September 30, 2024

**THE UNIVERSITY OF NEW ORLEANS
SCIENCE LAB UPGRADES PHASE III
H/S PROJECT NO. 23044**

**HOLLY & SMITH ARCHITECTS, APAC
2302 MAGAZINE STREET
NEW ORLEANS, LOUISIANA 70130**

This addendum forms a part of the Contract Documents and modifies the original specifications and drawings issued for bidding to the extent noted hereinafter.

DETAILS OF STUD PARTITION PERPENDICULAR TO CONG. JOISTS
SCALE: 1/4" = 1'-0"

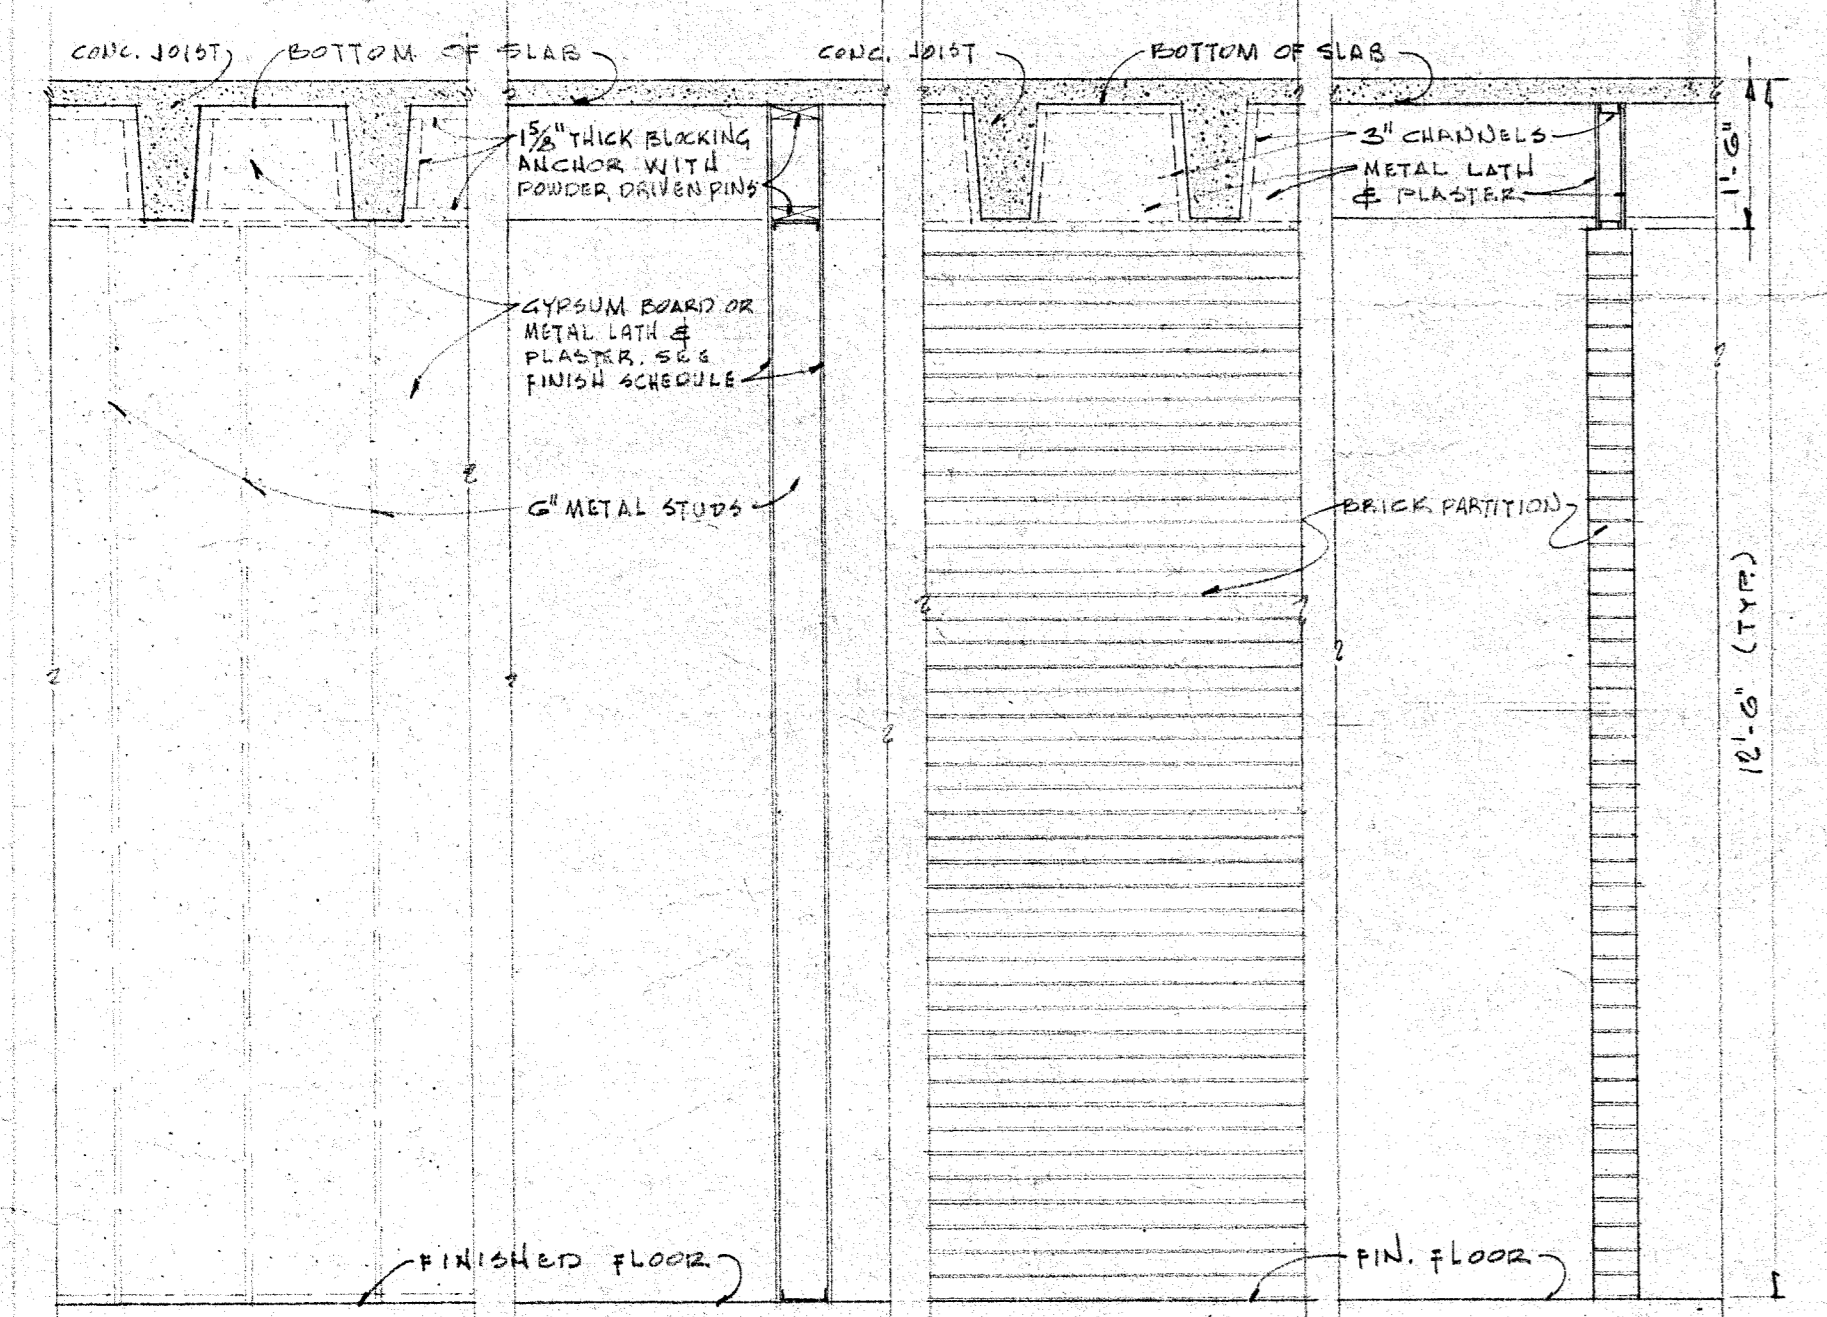
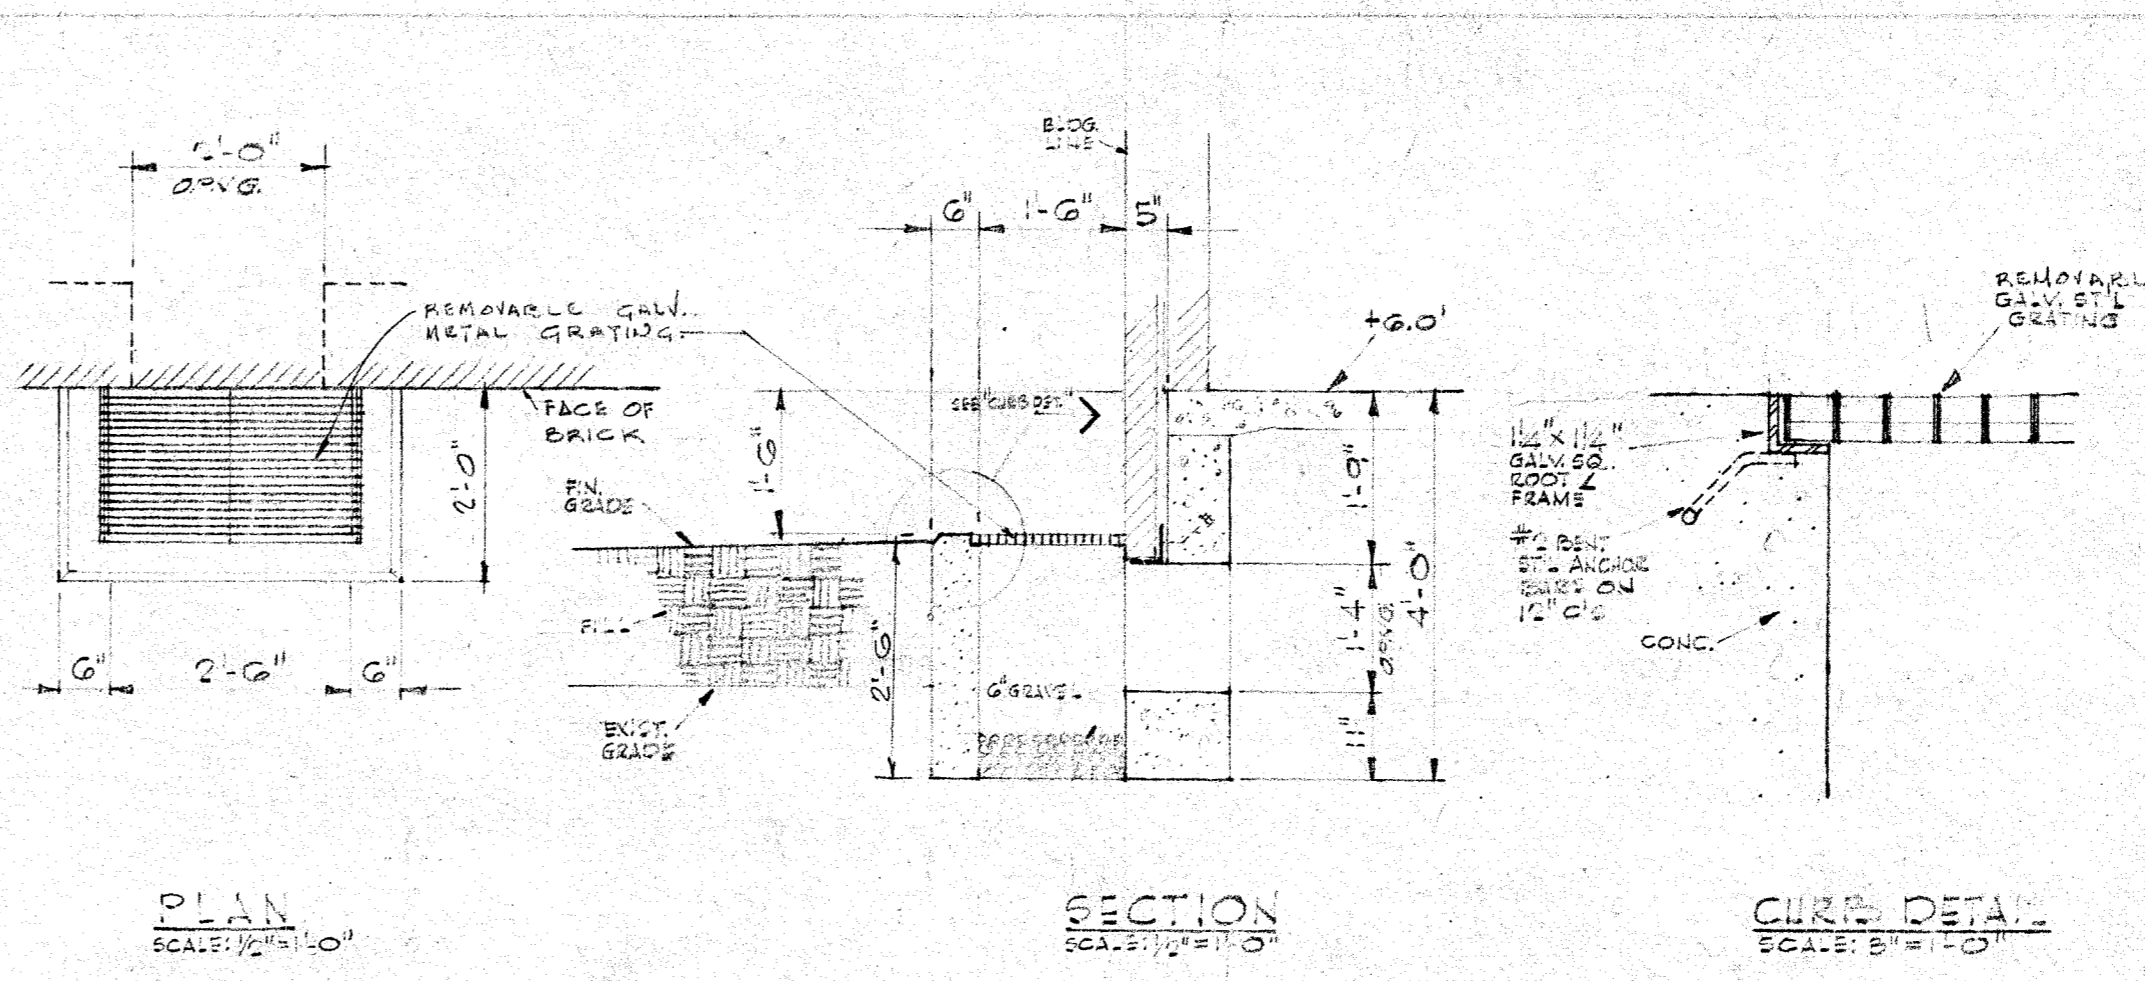
- 2.1 A copy of the original drawings identifying access to the crawl space, crawl space plumbing plan, an existing section of the crawl space, and images of the crawl space are included in this addendum for reference only. Contractor must verify existing conditions on site.
